California Regional Water Quality Control Board
Santa Ana Region

Staff Report

SUBJECT: Amendments to Waste Discharge Requirements for the California Street Landfill, City of Redlands, San Bernardino County, Order No. R8-2008-0094

ORDER NO. R8-2008-0094

Attachment D - Table 1

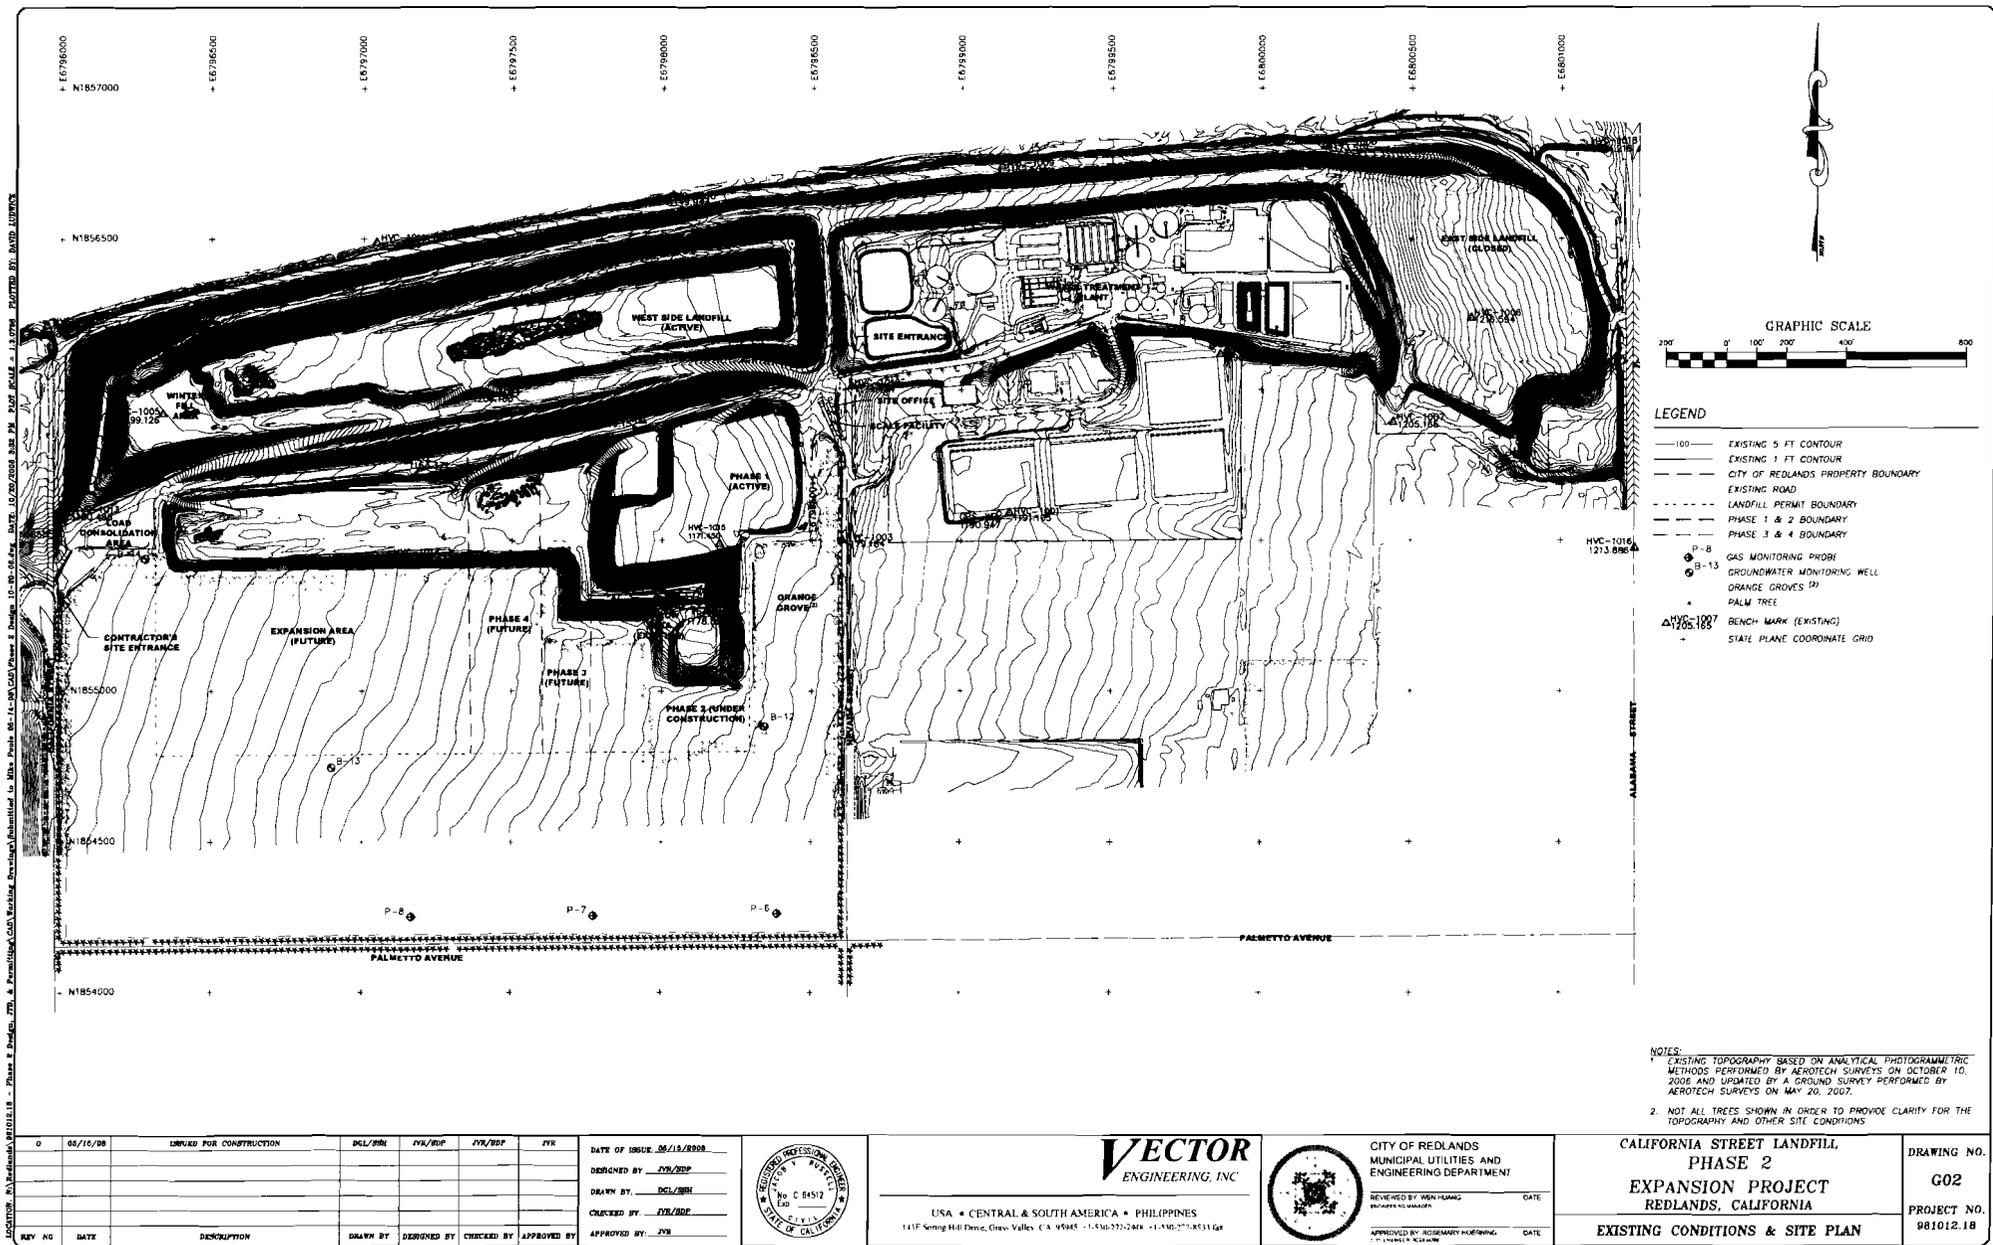
6. Replace Attachment D, Table 1 of Order No. R8-2004-0008 with the following:

<u>Program</u>	<u>Monitoring Parameters</u>	<u>Monitoring Frequency</u>
Detection monitoring	pH, total dissolved solids, chloride, sulfate, nitrate (as nitrogen), bicarbonate, carbonate, chemical oxygen demand (COD), hydroxide, dissolved carbon dioxide, total alkalinity, perchlorate , and 47 Appendix I VOCs ⁷	Quarterly
COC-List 1 analysis ⁸	General minerals ⁹ and Appendix II constituents ¹⁰	Once every five years
COC-List 2 analysis ¹¹	¹²	Once every five years
Vadose zone monitoring	Methane (field), total gaseous non-methane organic (TGNMO), and the 17 core group VOCs per SCAQMD Rule 1150.1	Quarterly
Surface water monitoring ¹³	pH, total dissolved solids, chloride, sulfate, nitrate (as nitrogen), bicarbonate, carbonate, chemical oxygen demand (COD), hydroxide, dissolved carbon dioxide, total alkalinity, and 47 Appendix I VOCs ⁷	Quarterly
Leachate monitoring	General minerals ⁹ and Appendix II constituents ¹⁰ (see also paragraph B.1.b.v of M&RP No. R8-2004-0008)	Annually
